# Gus Engeling WMA- ADA Evaluation

**WMA- Gus Engeling, Tennessee Colony TX, ADA Evalua**

**Accessibility Evaluation**

**Inspection Date: 07/07/2022**

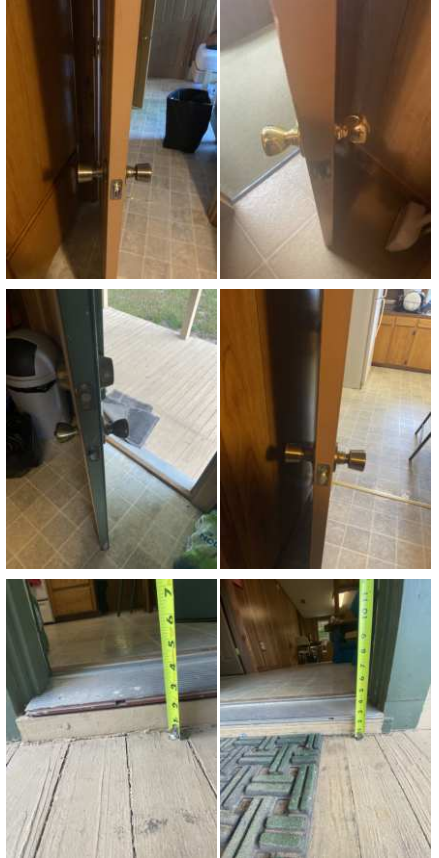
36	Structures on Property (Public) : HQ Office (Interior) - Restroom (Unisex)	The restroom facilities serving the facility are not on an accessible route. Bathing and toilet facilities that serve buildings, facilities or portions of buildings or facilities that are required by these standards to be accessible to persons with disabilities, shall be on an accessible route.	Restroom and parts of HQ interior not accessible due to pathway narrowing, projections into walkway, or entrance door width compliance.	<a href="https://www.access-board.gov/ada/#ada-213_1">https://www.access-board.gov/ada/#ada-213_1</a>	2012 TAS Section: 213.1  2010 ADAS Section: 213.1  2015 ABAAS Section: F213.1
